REMARKS

Applicant : Nobuaki EMA
Serial No. : 09/933,691
Filed : August 21, 2001
Page : 6 of 6

Attorney's Docket No.: 10830-074001 / A36-
134162M/NHK

FIG. 3 (Prior Art)

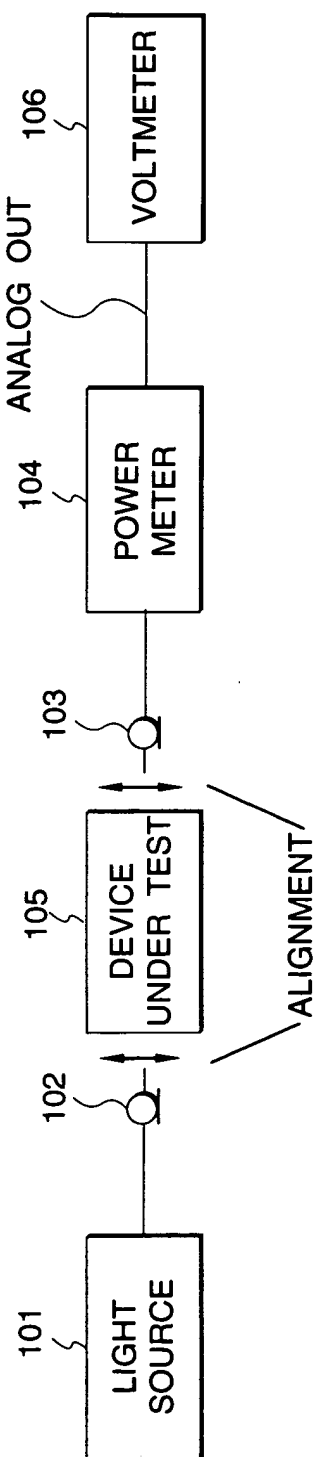
The Office action rejected FIG. 3 for failing to include the legend "Prior Art."

Applicants submit a proposed corrected drawing sheet labeled FIG. 3 with the legend "Prior Art." The substitute drawing sheet labeled FIG. 3 also has been corrected to include the reference "100" mentioned in the description.
